Product Change Notification / CAAN-20EDKO108

CCB 6045 Initial Notice: Qualification of MMT as a new assembly site for selected AT28C010x and AT28LV010 device families available in 32L PLCC (11.5x14x3.37mm) package.

CCB 6045
Pre and Post Change Summary
PCN #: CAAN-20EDKO108

Pre change

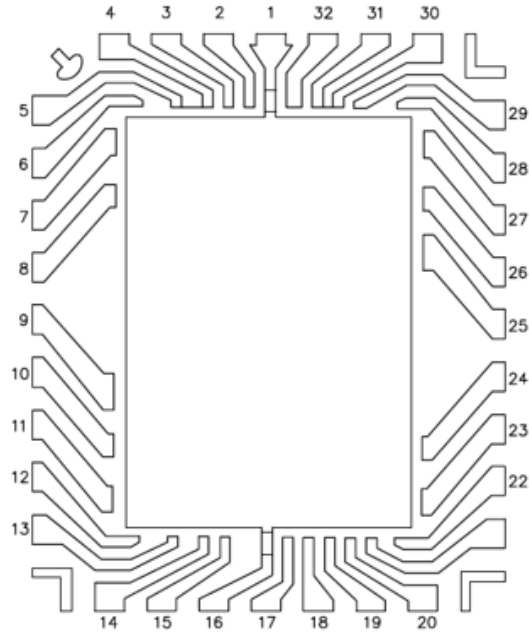
Lead frame DAP surface prep	Ag Spot Plated
Lead Plating	Matte Tin
Lead-Frame Paddle Size	391x275 mils

Post change

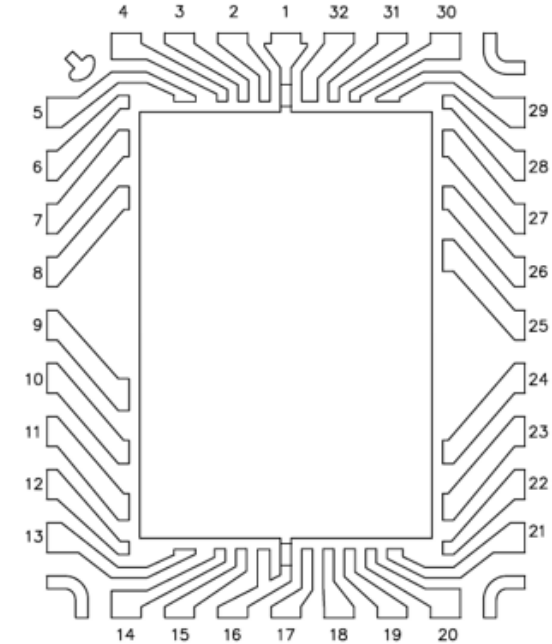
Lead frame DAP surface prep	Ag Ring Plated
Lead Plating	Matte tin
Lead-Frame Paddle Size	401x275 mils

Pre change

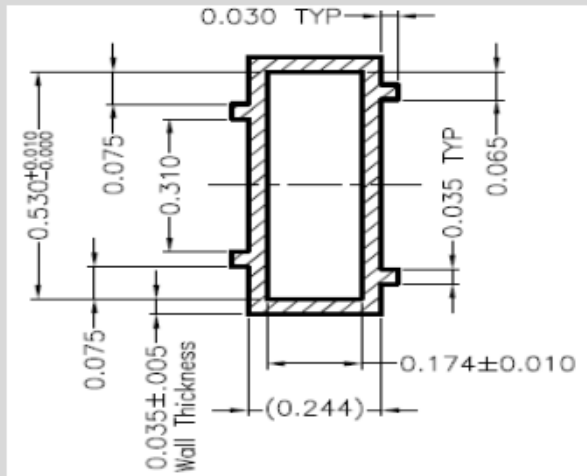
Length: 20.40+/-0.10 inch

Width: 0.600+0.015/-0.005 inch

Tube Opening Length (A): 0.174 + 0.010 inch

Tube Opening Width (B): 0.530+0.010/-0.000 inch

Wall thickness (T): 0.035 + 0.005

Post change

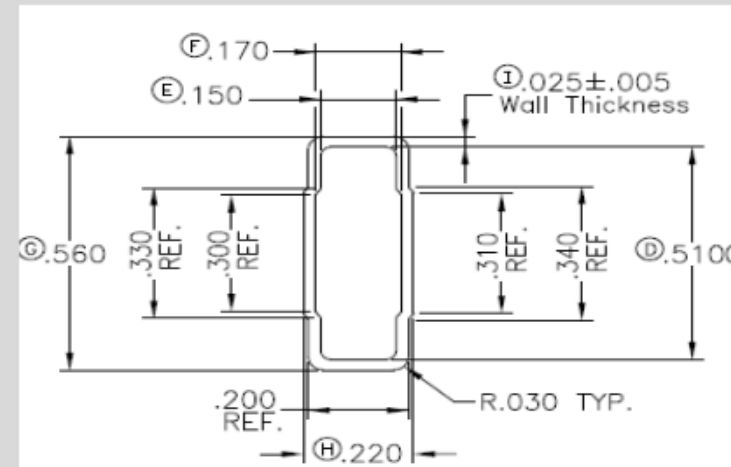
Length: 21.70 ± 0.045 inch

Width: 0.560 ± 0.015 inch

Tube Opening Length (A): 0.170 ± 0.010 inch

Tube Opening Width (B): 0.510 ± 0.010 inch

Wall thickness (T): 0.025 ± 0.005 inch

Tube Stopper

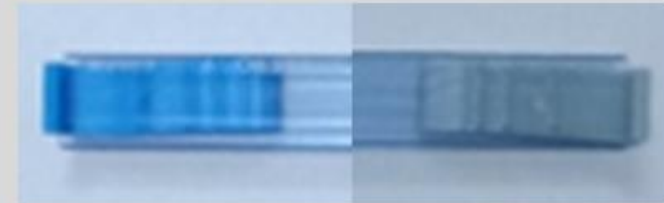
Blue colored stopper only on both ends

Blue and gray colored stopper
